## **NOTICE OF PUBLIC MEETING**

**Governmental Body: Van Meter Planning and Zoning Commission**

CITY OF VAN METER, IOWA  
PRELIMINARY PLAT - HILLTOP  
FINAL PLAT - HILLTOP  
REVIEW COMMENTS

CITY OF VAN METER, IOWA  
VAN METER COMMUNITY SCHOOL DISTRICT  
EAST ATHLETIC CAMPUS  
PRELIMINARY SITE PLAN  
REVIEW COMMENTS

DATE	MSY 26, 2013
SHEET NUMBER	1092
SHEET NAME	EAST ATHLETIC CAMPUS
SHEET NUMBER	SP.1

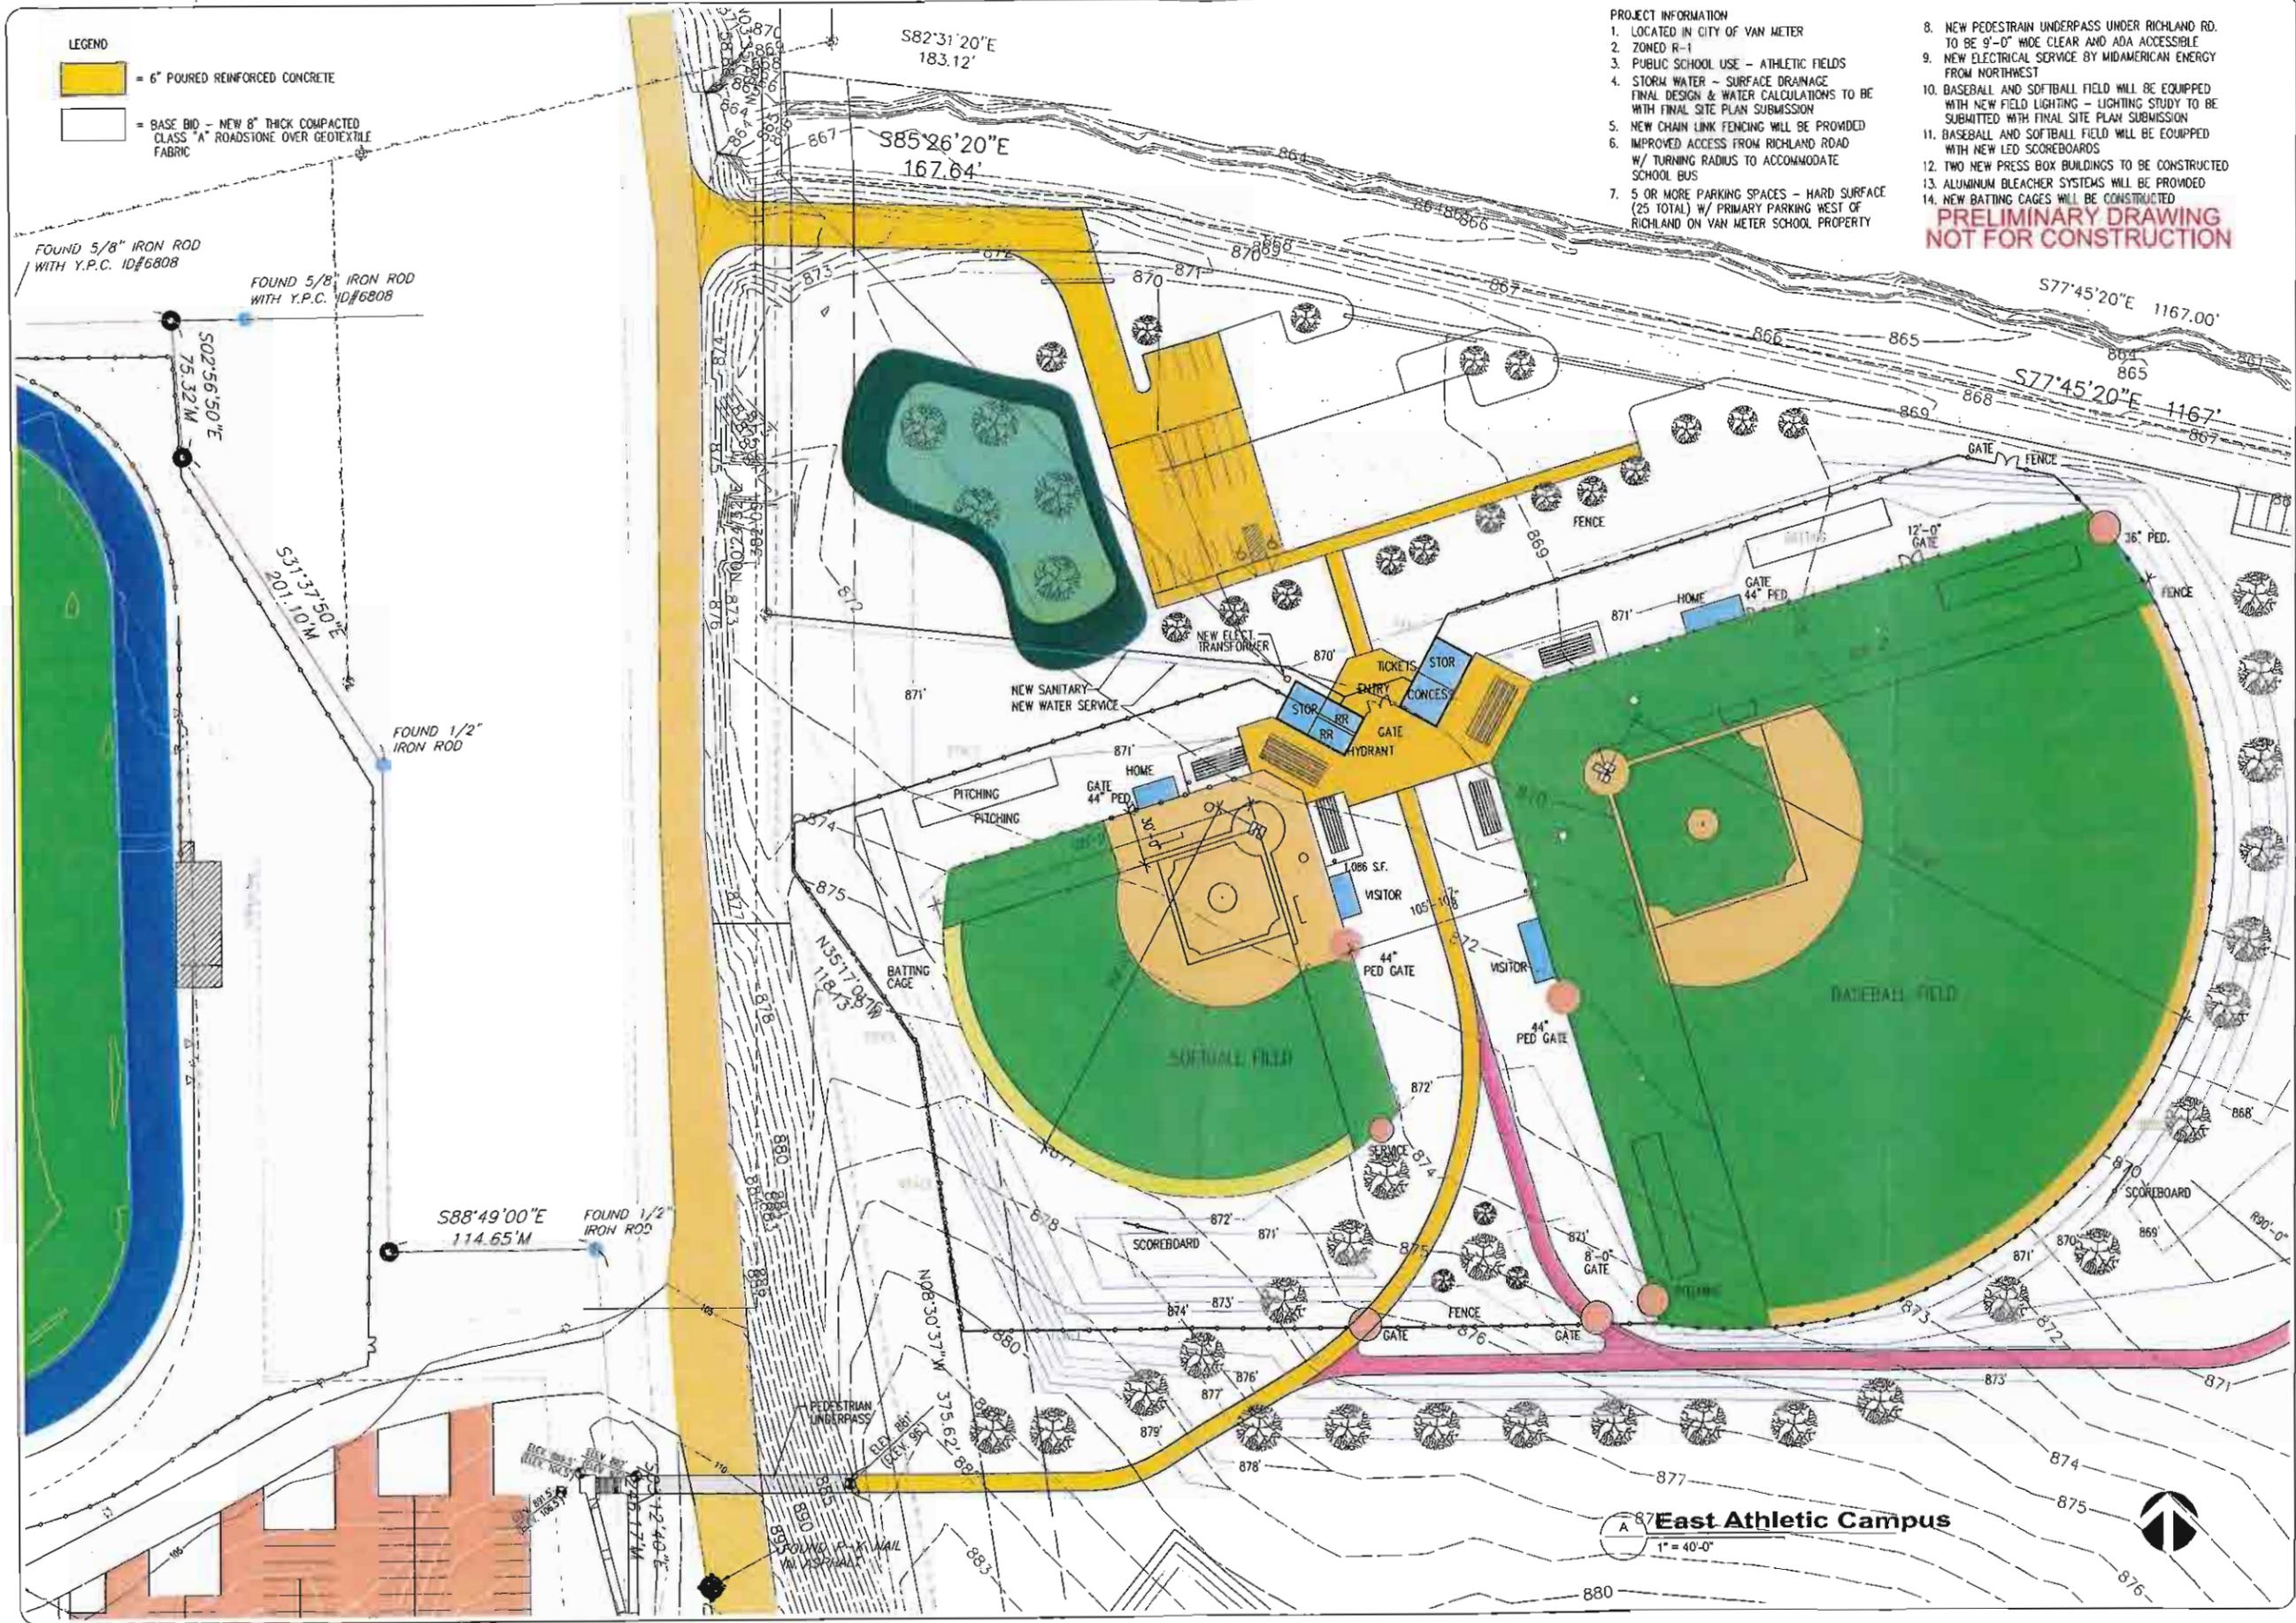
2. Although not shown on the site plan, there is an existing hydrant located on the east side of Richland Road south of the driveway. The hydrant is approximately 350 feet from the new buildings. The coverage to the existing buildings would be considered acceptable and no additional hydrant is necessary.

3. The site plan shows a sanitary sewer extending south from the existing sanitary sewer to a point directly west of the new buildings. The site plan contemplates this sewer would be part of the public sewer system. This portion of the sanitary sewer is consistent with the ongoing discussions between the City and school district. This portion of the sanitary sewer will be funded by the school district. At this time it has not been determined whether the sewer will be physically constructed by the school district or if the sewer will be constructed by the City of Van Meter as part of a larger project.

5. The City of Van Meter has identified a longer term interest in a sanitary sewer along Richland Road to serve areas south of the school district property. A portion of this sewer is shown on the site plan. Although the site plan does not show an extension of the sewer south toward the south property line, the City anticipates this sewer will be constructed. There would be advantages to the City to extend the sewer at least to the south side of the pedestrian underpass prior to completing the construction of the site plan improvements. This reach of sewer is currently subject to discussions between the City, the school district and another property owner.

6. The preliminary site plan shows a stormwater detention basin in the southwest corner of the site. No detailed information is provided relative to the stormwater detention basin.

7. Note 4 on the preliminary site plan indicates the stormwater drainage design and calculations will be submitted with the final site plan. A review of stormwater drainage will need to be deferred until the final site plan submittal.

8. Access to the site is by a paved driveway that enters Richland Road at approximately the location of the existing driveway.
9. The site plan does not show the radius of the driveway at the connection to Richland Road. Note 6 indicates the driveway will be constructed to accommodate the turning radius of a school bus. As part of the final site plan it is requested the radius of each return be identified. The concern with respect to the turning radius of the driveway relates to the proximity of the driveway to the curve on Richland Road. The driveway radius needs to be large enough to avoid the need for school buses to cross over the centerline of Richland Road while entering or exiting the athletic complex.

10. The proximity of the driveway to Richland Road creates two potential conflicts with respect to traffic movement. Vehicles traveling southerly around the curve will have a limited site distance for vehicles that would be leaving the athletic complex south on Richland Road and any vehicle southbound on Richland Road that would stop to turn east into the driveway. From a site visibility perspective it would be preferable if the driveway were located farther to the south. The writer recognizes the proposed location of the driveway may better suit the site by keeping the

14. The site plan shows approximately 25 paved parking stalls in the west part of the parking lot north of the softball and baseball fields.
15. The configuration of the site plan suggests there will be additional granular parking in the parking lot east of the paved parking. Although the parking is not delineated it would appear an additional 50 to 70 parking stalls are anticipated in the non-paved portion of the parking lot.

16. The site plan shows approximately 34 parking stalls north of the practice field. These parking stalls appear to be unpaved.
17. The site plan includes a pedestrian underpass under Richland Road. The writer previously indicated to representatives of the Van Meter Community School District the City would not be opposed to open cut installation of the pedestrian underpass even though it would require a closure of Richland Road. This method of construction may be preferable to tunneling the pedestrian underpass in place. Due to the limited cover over the top of the underpass the combination of size and limited cover poses an increased risk of subsidence during any tunneling operation.

23. The zoning ordinance would require all parking areas of five or more parking stalls to be surfaced with portland cement concrete, asphaltic cement concrete or a similar material. The site plan shows approximately 25 paved parking stalls and a significant number of granular surface parking stalls. The granular surface parking stalls would not appear to conform with the requirements of the zoning ordinance.

24. A reasonable interpretation of the parking requirements would lead to the conclusion the driveways leading to parking that is required to be hard surface must be hard surfaced. In the case of the preliminary site plan the access to the west parking is paved. However, the driveway access to the east parking is granular surfaced. It would appear the unpaved driveway leading to the east parking would not meet the requirements of the zoning ordinance.

26. The site plan indicates there will be illuminated scoreboards at the athletic fields. The zoning ordinance does not specifically address scoreboards. The ancillary uses allowed in the zoning ordinance include one for a school to have a bulletin board sign of not more than 40 square feet. There are restrictions relative to illumination.

It is the interpretation of the zoning administrator scoreboards attached to and integrally a part of an athletic field would not be considered a sign as contemplated under the zoning ordinance. To be considered an integral part of an athletic field the scoreboard will need to function in a traditional scoreboard manner that it is operated only when the field is in use. If the scoreboard is used at other times for purposes of displaying messages, in that event it would appear the scoreboard would be subject to the limitations of the sign allowed under the zoning district regulations.
